**WHEELING PLAN COMMISSION
THURSDAY, AUGUST 24, 2017 6:30 P.M.**

RE: **Docket Nos. PC 17-14 and SCBA 17-31**
Burger King
425 W. Dundee Road
(PC 17-14) Site Plan Change to Special Use Ordinance No.
1997 for Building and Site Modifications to an
Existing Drive-Thru Restaurant
(SCBA 17-31) Appearance Approval of Wall Signs

At the August 10, 2017 Plan Commission meeting, Docket Nos. PC 17-14 and SCBA 17-31 were tabled so that the petitioner could address the following suggestions made by the Plan Commission (**staff update provided in bold**):

Re: Burger King 3953 Remodel
425 W. Dundee Road
Response to Recommendations and/or Conditions on Decision and Comment Form

DEMO SITE PLAN

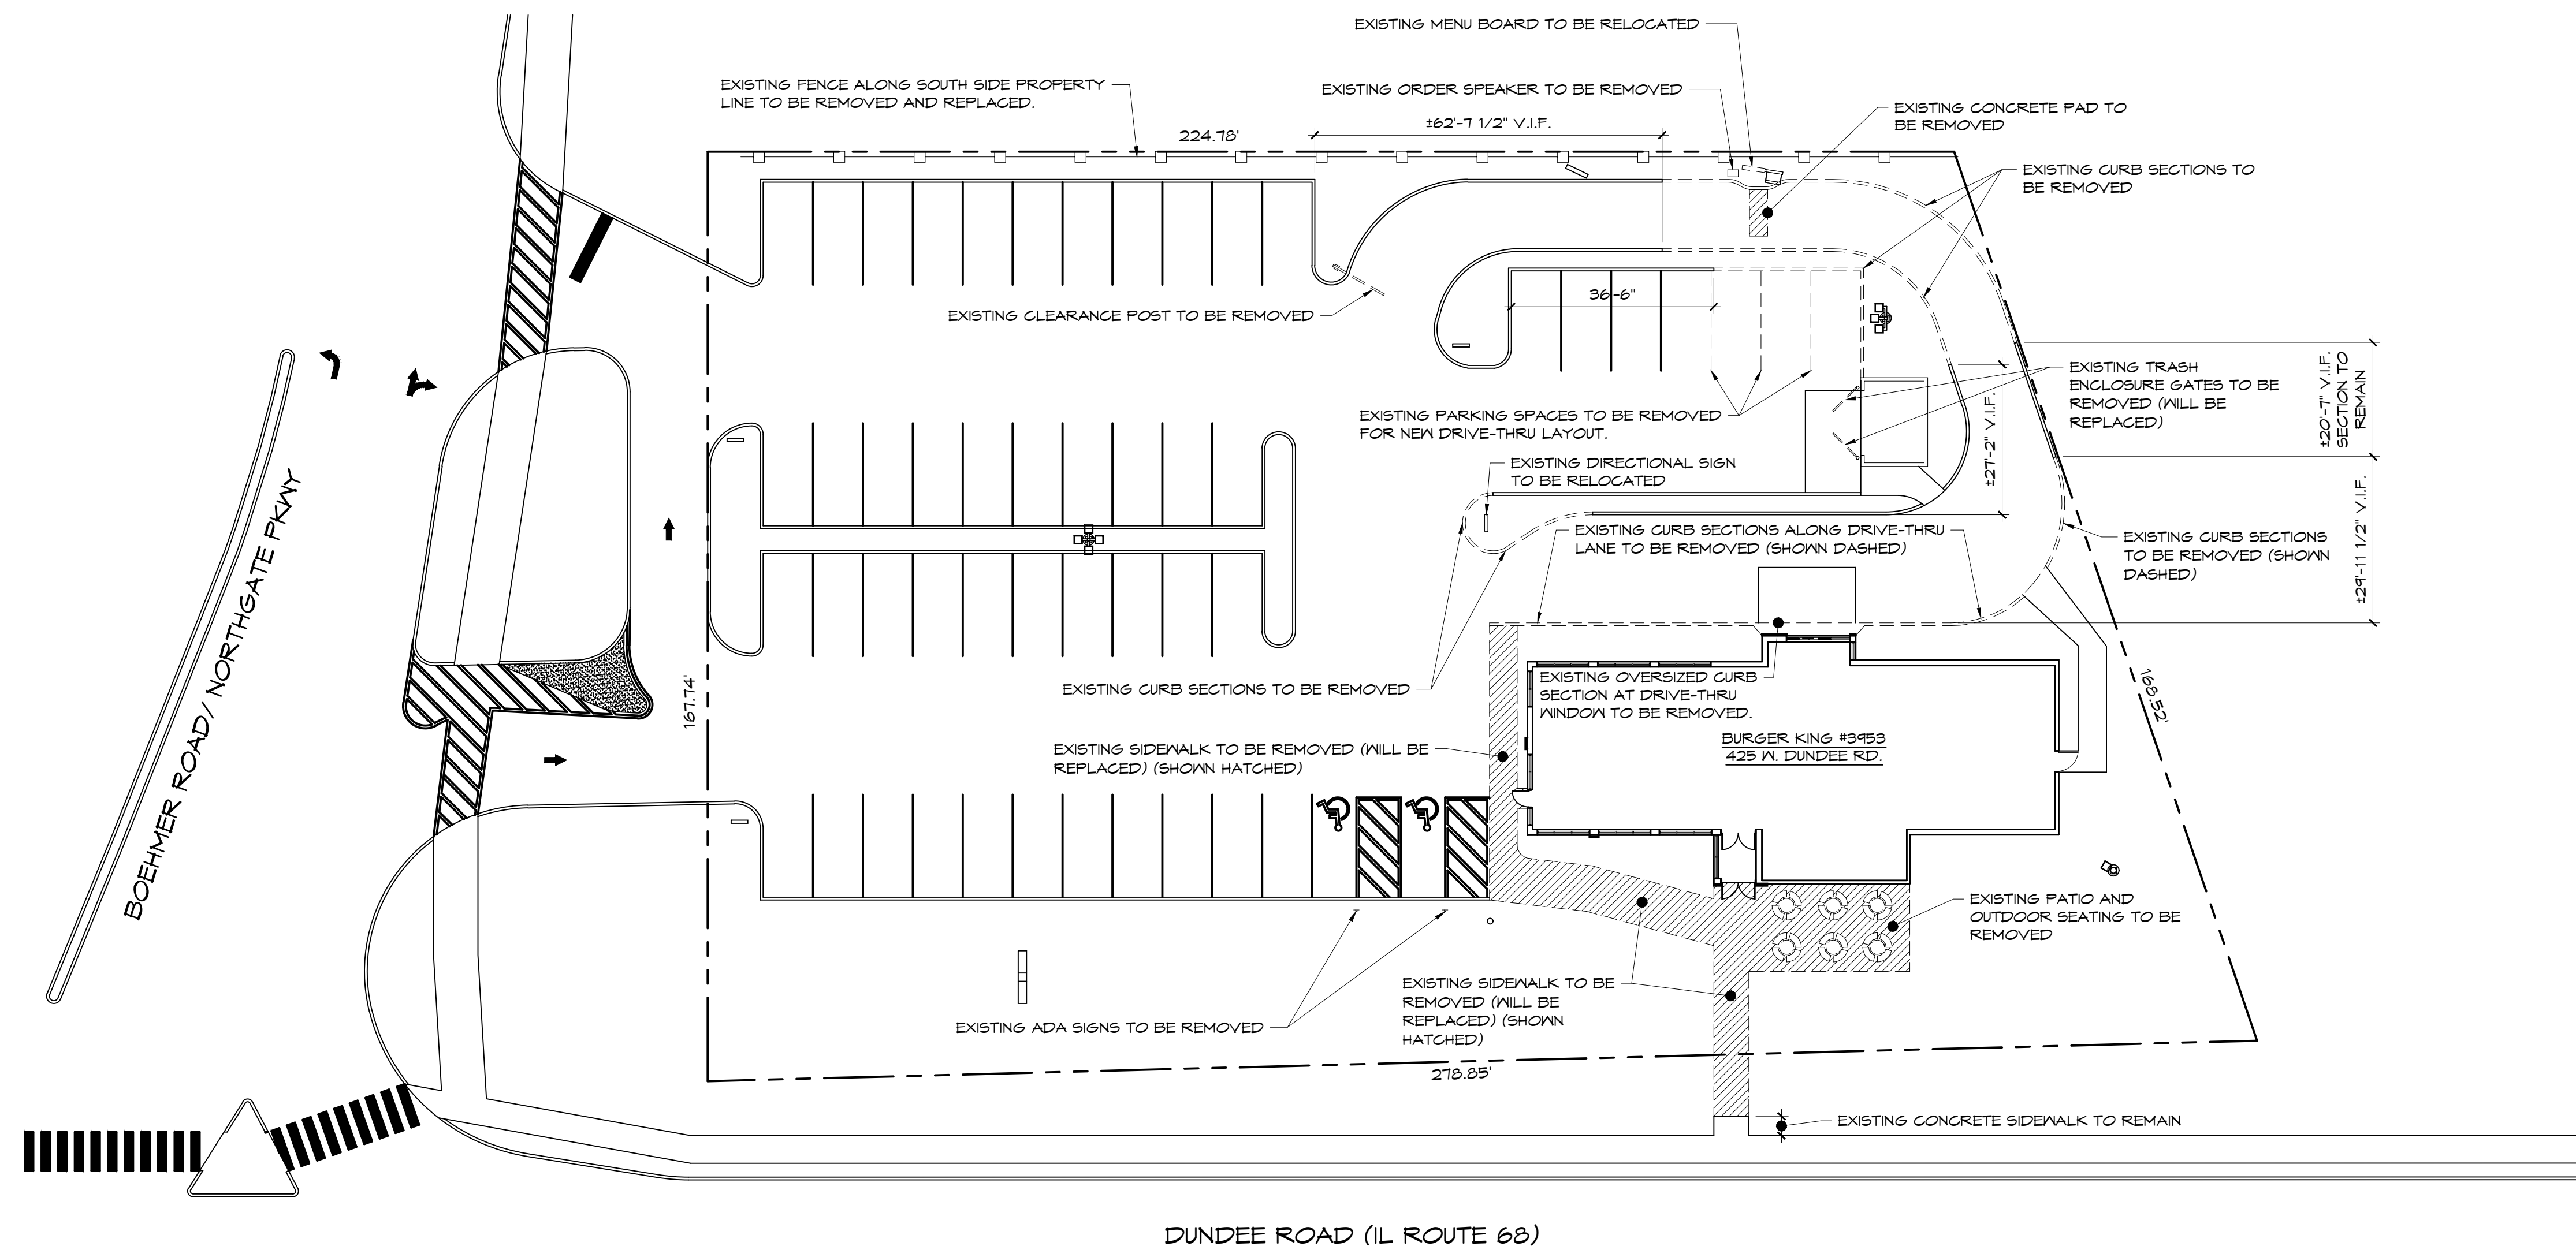
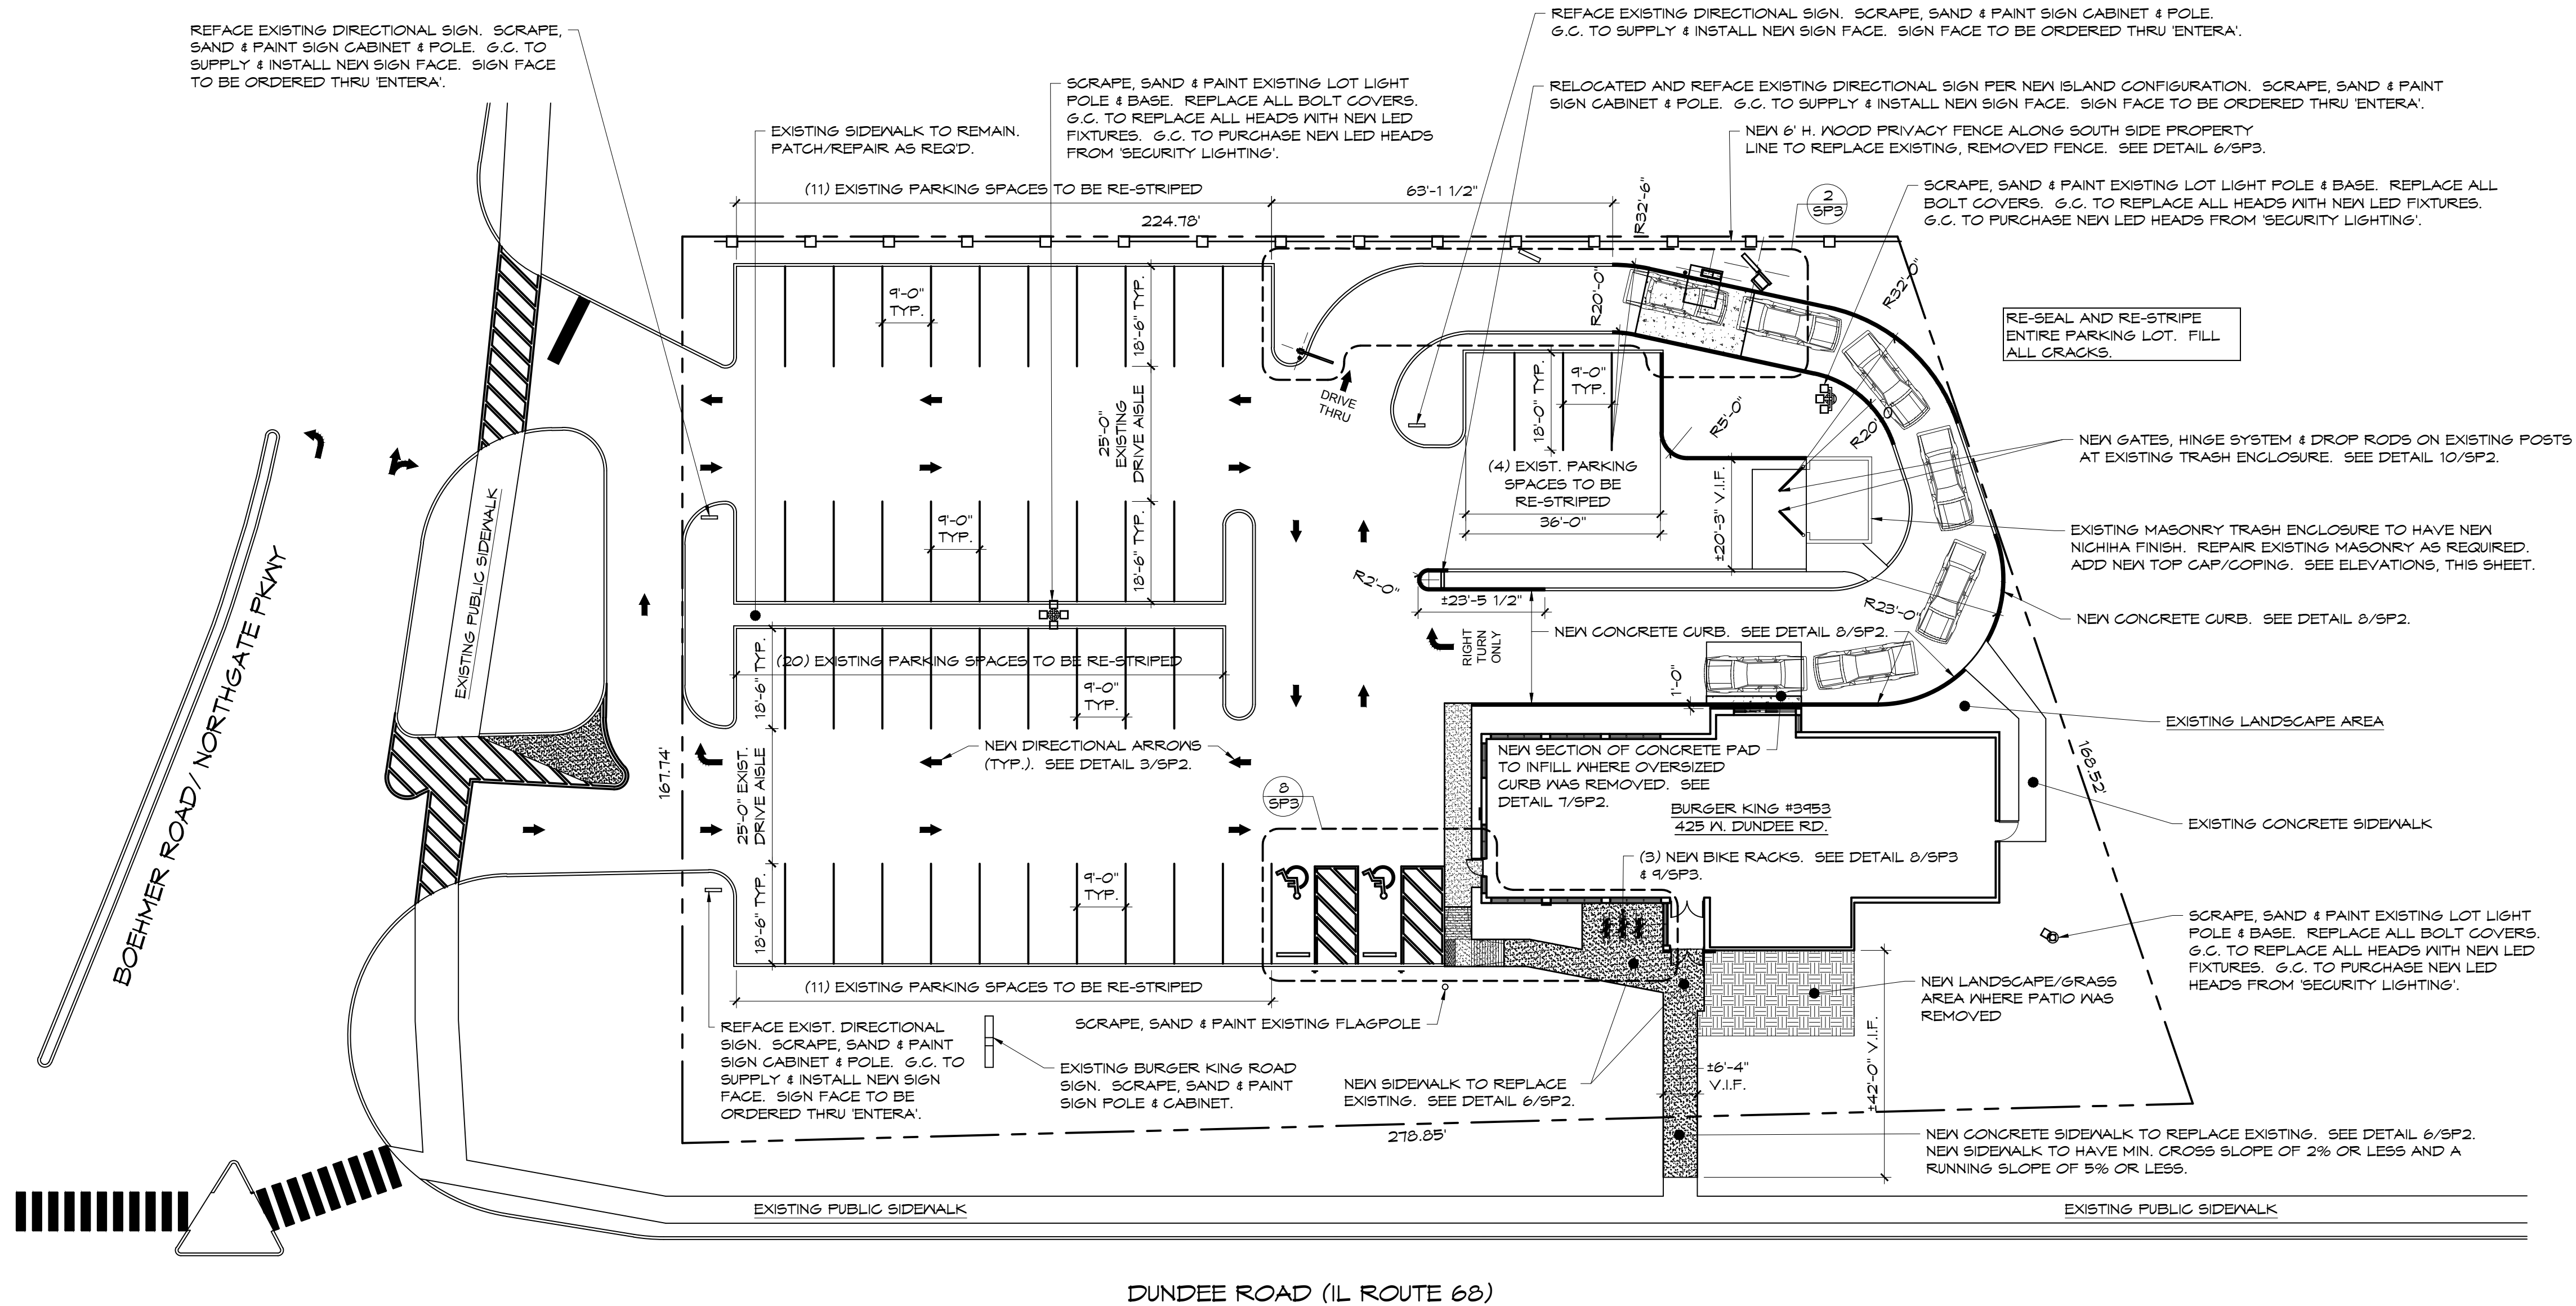
6. Consider the Wheeling Town Center plan to verify safe access in and out of the subject property. **The proposed site configuration has been adjusted to accommodate the new Northgate Parkway configuration.**

7. Reconsider vehicle access out of the drive-thru. **The existing curb peninsula has been removed and signs and pavement markings have been added to the drive-thru to provide for safe traffic throughout the site.**

Only in order to provide safe vehicular access around the Burger King parking lot. See updated SP-0.1 and SP-1.

PROPOSED EXTERIOR ELEVATIONS

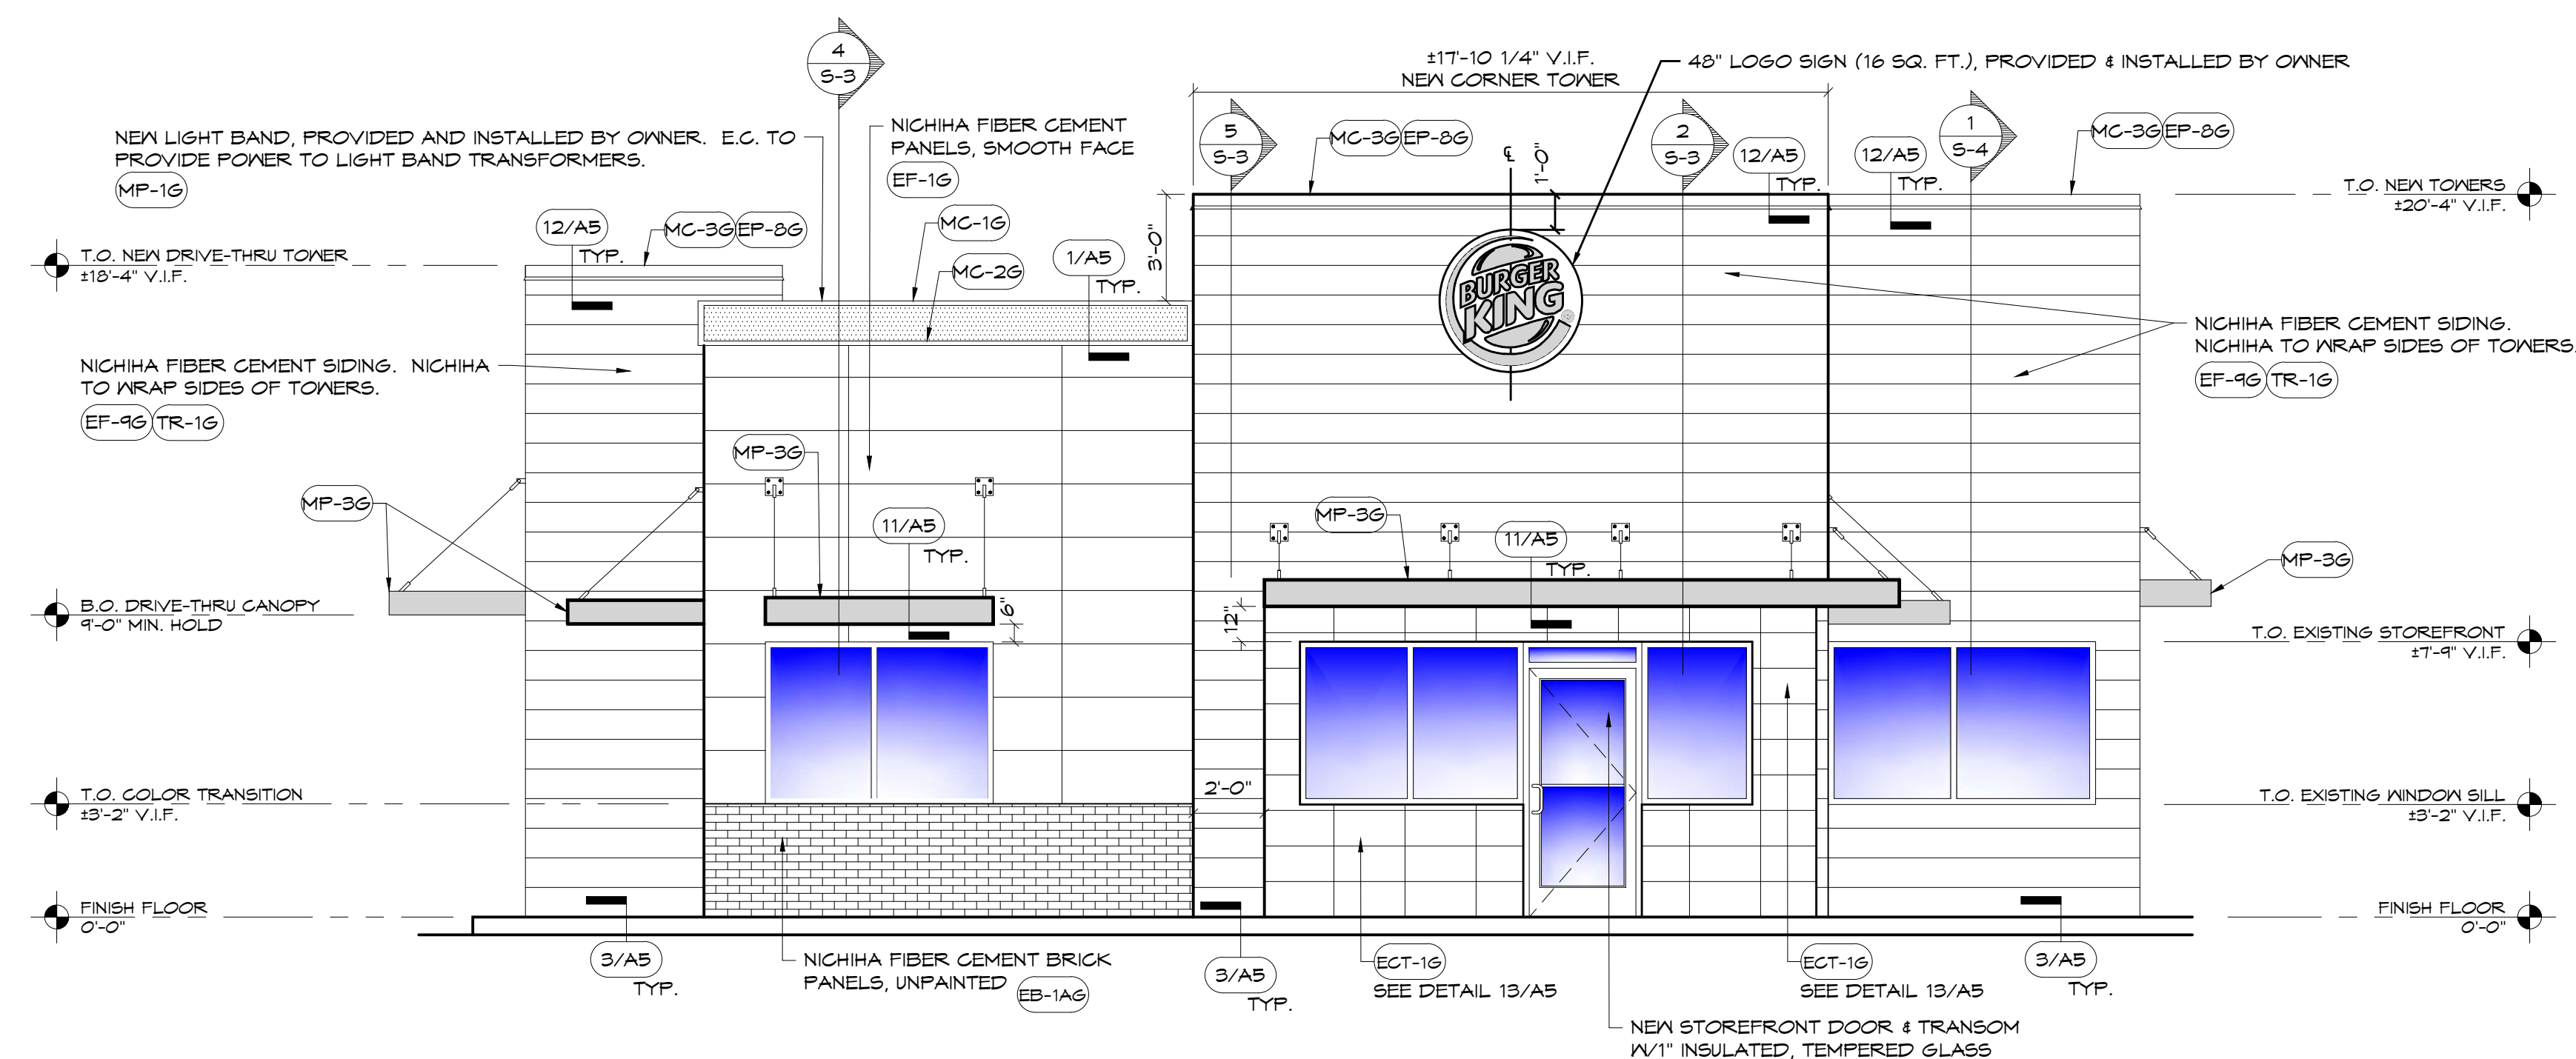
5. Provide alternatives to painting existing brick and painting new fiber cement brick panel. **The plans have been revised so that no painted wall materials will be used. All existing brick will be replaced with Nichiha fiber cement panels.**

Elevation Plan Review: The proposed elevation modifications will create a new architectural style for the existing building. The mansard roof will be replaced with a flat roofs and tower elements. As requested by the Plan Commission on August 10th, the petitioner has addressed paint maintenance issues. The existing brick walls will not be painted. They will be replaced by Nichiha fiber cement panels in both unpainted brick panels and smooth face horizontal boards. Horizontal fiber cement panels in “tanners taupe” color will be located at and above the windows. Wall areas below the existing windows, which were clad in wood panels, will be replaced with unpainted fiber cement brick panels. The existing brick on the lower portion of the building will also be clad in unpainted fiber cement brick panels. New storefront windows and doors are proposed for the drive-through window and the entry doors on the north and east facades. Metal canopies will provide additional architectural detailing above the windows and doors. Two sheets of rendered elevation plans have also been provided.
